**PLANNING AND ZONING COMMISSION AGENDA  
DECEMBER 13, 2023  
7:00 p.m.**

RE: The Prairie Encore Amended Area Plan

Subject: Amended CUP, PUD Area Plan & Final Plan Request  
Dardenne Prairie Project No. 972260

Subject: Prairie Encore CUP/PUD Area Plan Amendment  
1<sup>st</sup> Review  
Dardenne Prairie Project No. 972260

AMENDED AREA PLAN

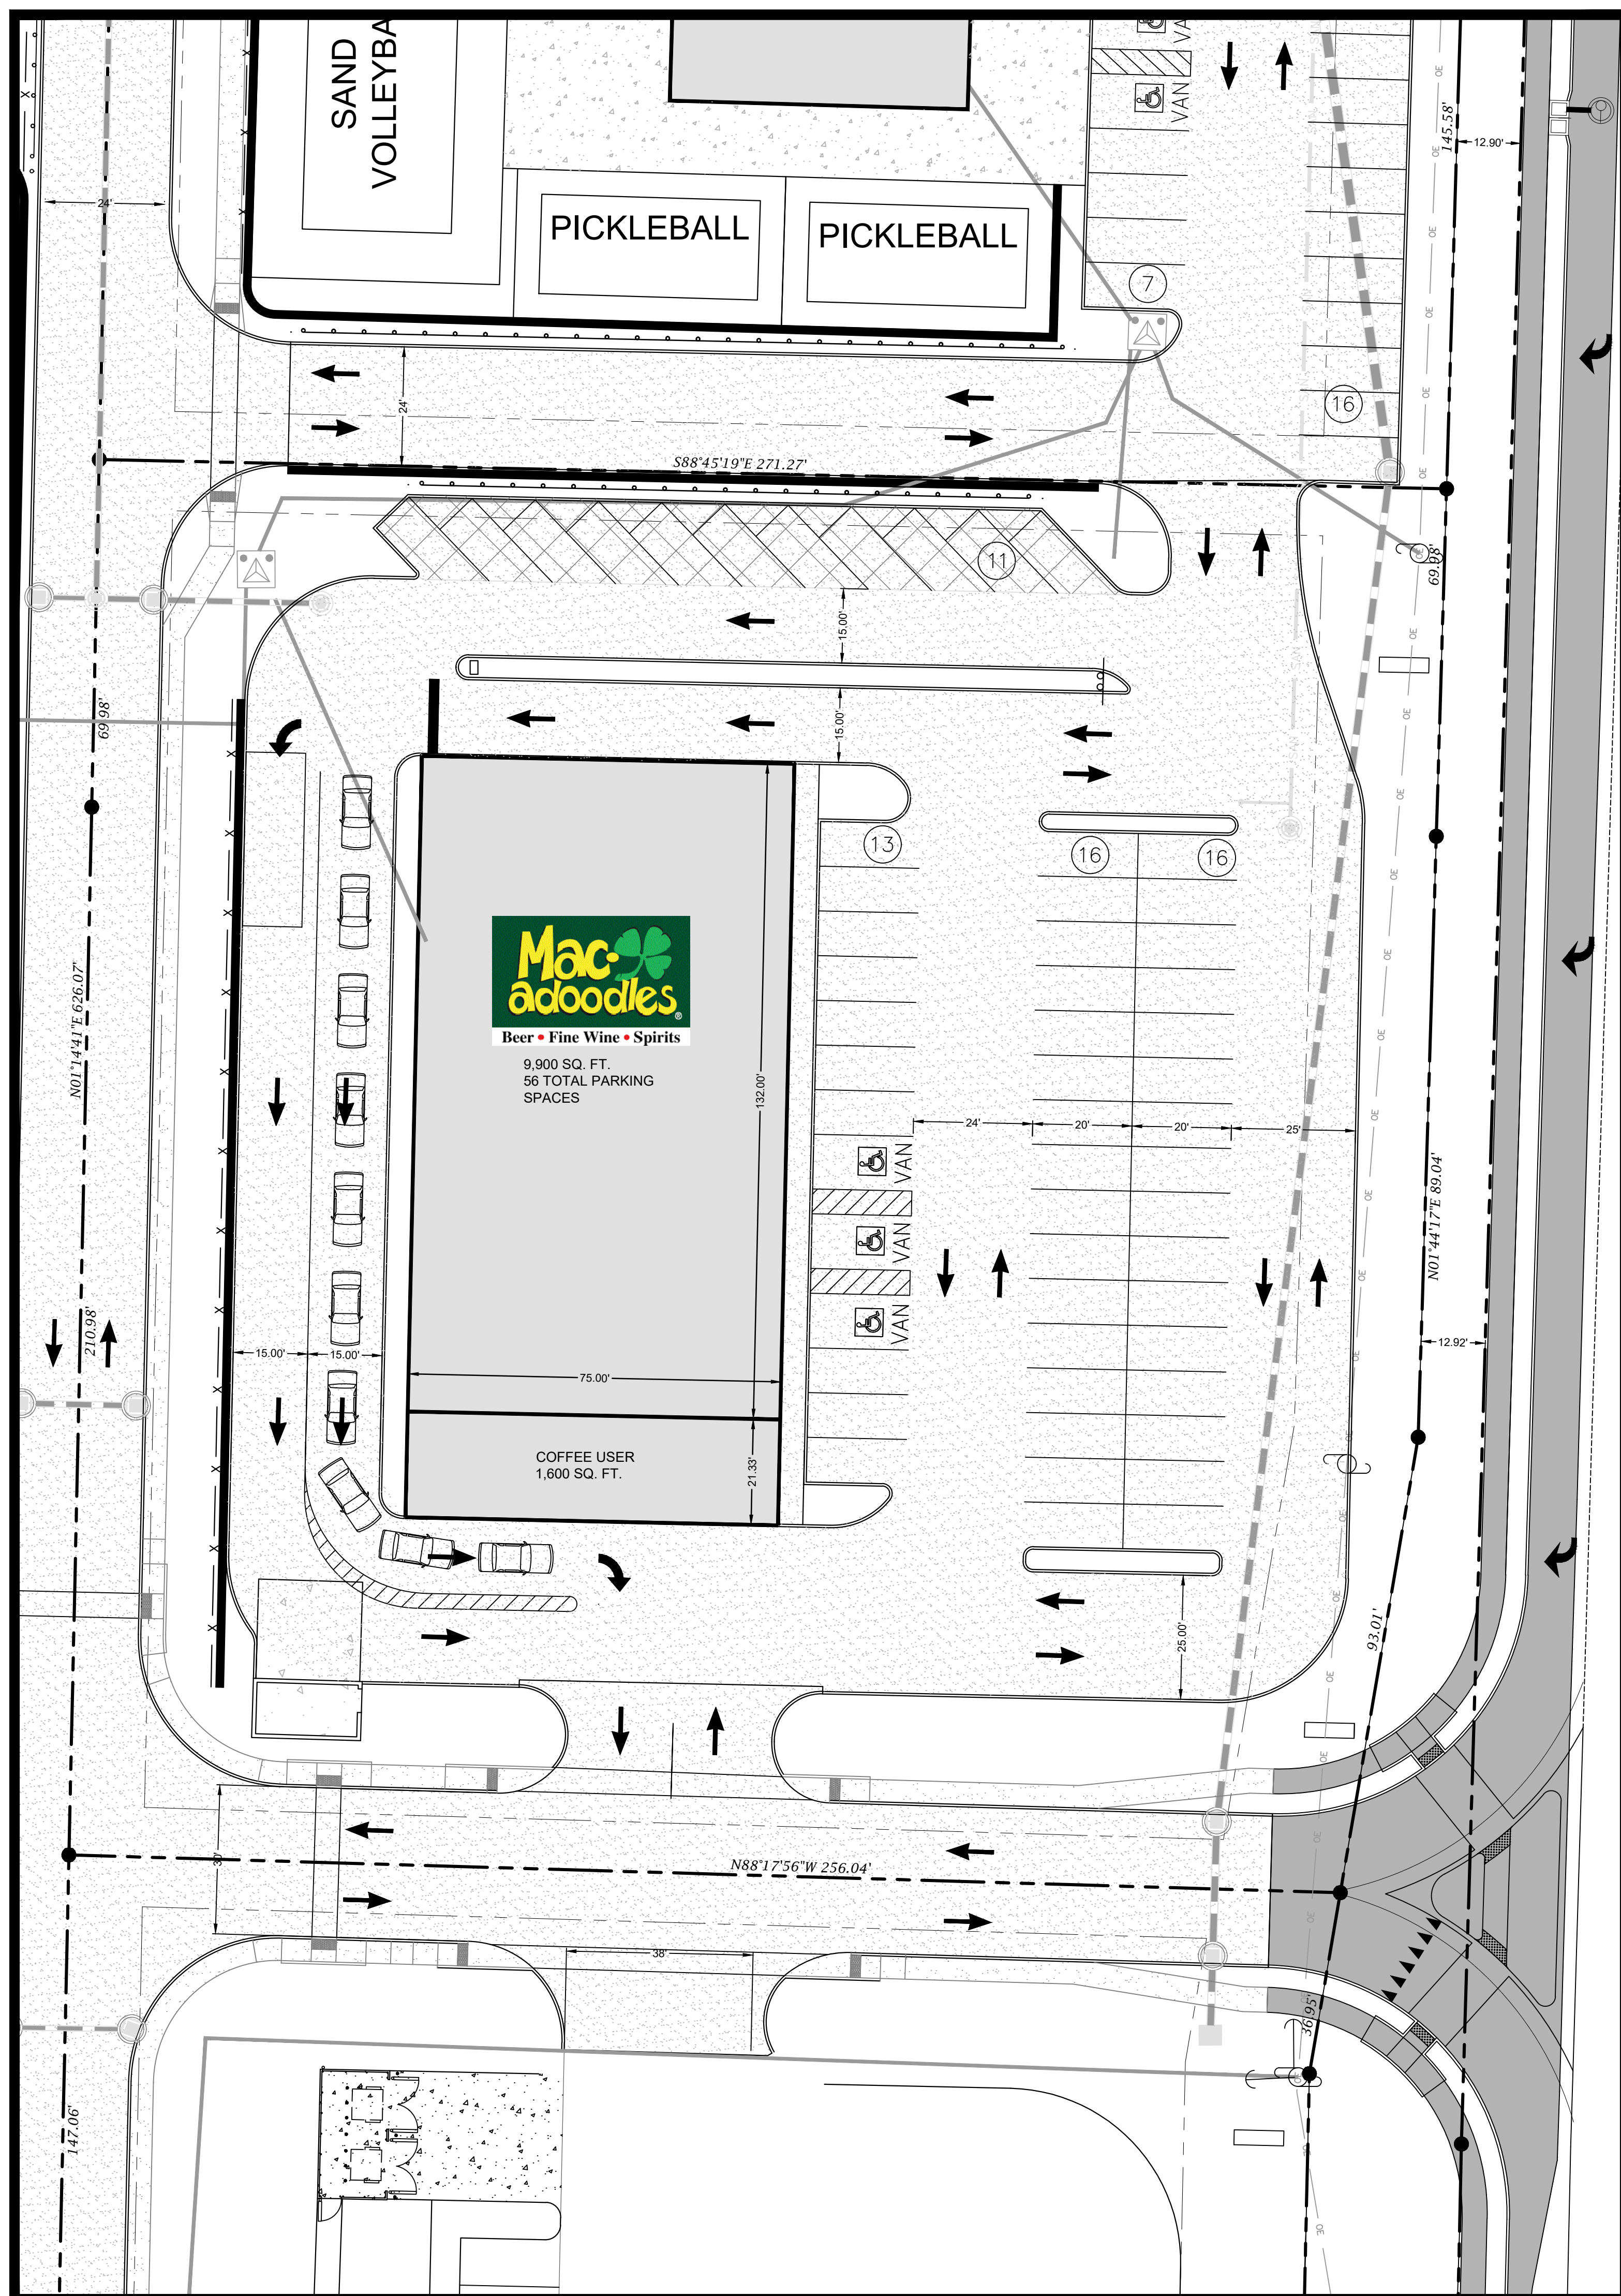
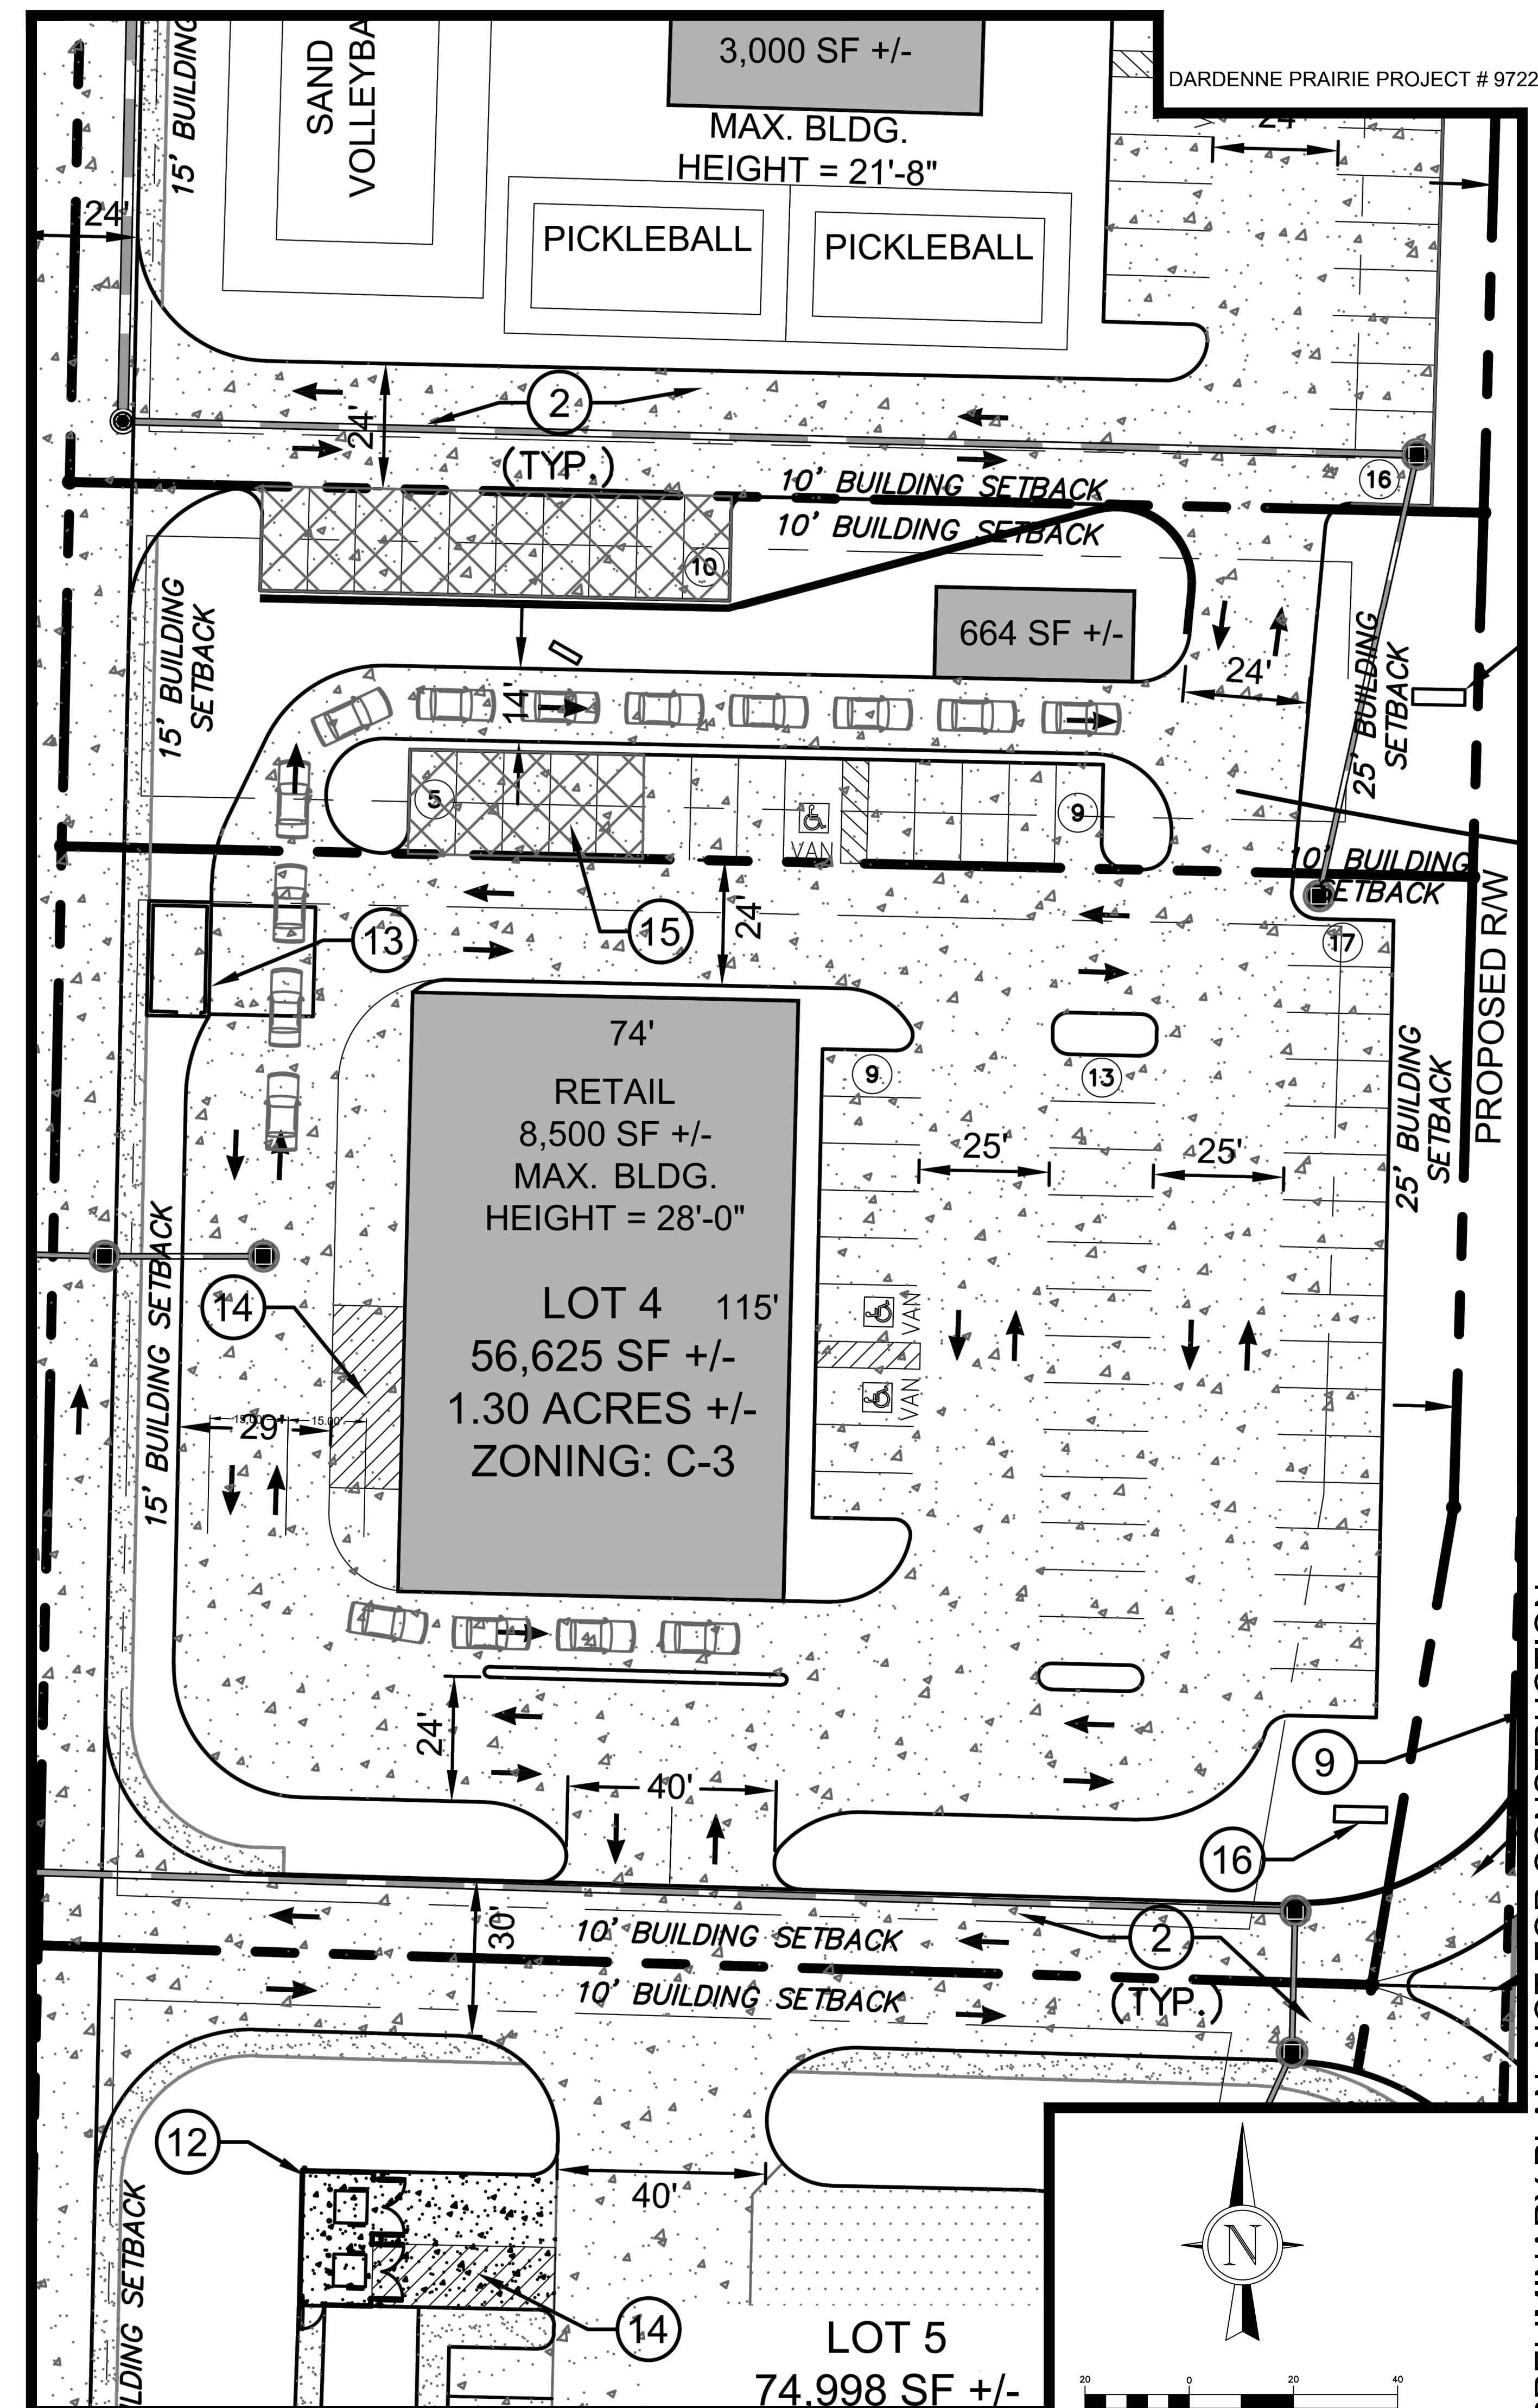
1. The approved Area Plan included **17,364 sf** of commercial retail space; the proposed Amended Area Plan includes **19,700 sf**. The total change in commercial retail space is an increase of 2,336 sf or 13.4%. As we discussed, according to Section 405.310 A.1., any change resulting in an increase over 5% in the square footage of commercial space shall be considered a "major change" and required to go through the same procedures and public hearings as the approved Area Plan. **As previously requested, please provide a site plan showing Lots 3 & 4 as approved on the original Area Plan overlaid with the proposed amendments to Lot 3. Also provide a narrative describing all the proposed changes, approved vs. proposed square footages, the percent change, and the rationale for the proposed amendments and the benefits gained.**

2. There is a parking surplus on Lot 3 (34 stalls required; 56 stalls provided). Meanwhile, there is a parking deficiency of 11 stalls for Lot 2; (Only 40 Stalls are provided, however, 50 stalls are required). **Please rearrange the "shared parking" on Lot 3 to be accessible from Lot 2 and relocate the lot line to encompass the shared parking. If a "Modular Block Retaining Wall" is proposed between Lots 2 and 3, please label it accordingly. Update the Parking Summary with the revised parking calculations.**

3. Provide a cross access easement between Lots 2 and 3 and Lots 3 & 4.
4. Please relocate the accessible stalls in front of each entrance of the uses proposed on Lot 3 in accordance with Section 405.640 A.3.

5. Provide the amended architectural elevations with the maximum height to the "Copper Cone Cap" and top the "Vault" from the finished ground level.
6. The parking lot is over 65' in width, therefore the according to Section 405.550 B.1; *"Not less than ten percent (10%) of the interior of a parking lot shall be landscaped. The interior of a parking lot shall be calculated by multiplying the number of parking spaces by two hundred seventy (270) square feet. Planting which is required along the perimeter of a parking lot shall not be considered as part of the interior landscaping requirement."*

required, (45 stalls X 270 sf = 12,150). Only 1,310 is provided throughout the entire Lot 3 which includes perimeter landscaping that shall not be considered as part of the interior landscaping requirement.

7. According to Section 405.550 B.3; *"The interior dimensions of any planting area or planting median shall be sufficient to protect the landscaping materials planted therein and to insure proper growth. Any protected planting strip where trees are to be planted shall be a minimum of seven (7) feet wide and shall be protected from vehicle overhang."* Only 5' islands are provided in the interior; please revise the plan as needed to meet this requirement.

8. Provide an exhibit showing the proposed "Modular Block Retaining Wall" proposed along the shared parking and west side of the drive-through lane on Lot 3 showing the proposed height.

9. Provide submittal and revision dates to all drawings as needed and note on the plan the date of the original approved Area Plan and Approved Final Plan.

10. Provide an explanation that addresses and includes signage, stop bars etc. at the potential conflict of the dual drive thru area so that the coffee shop stacking does not block the traffic flow.
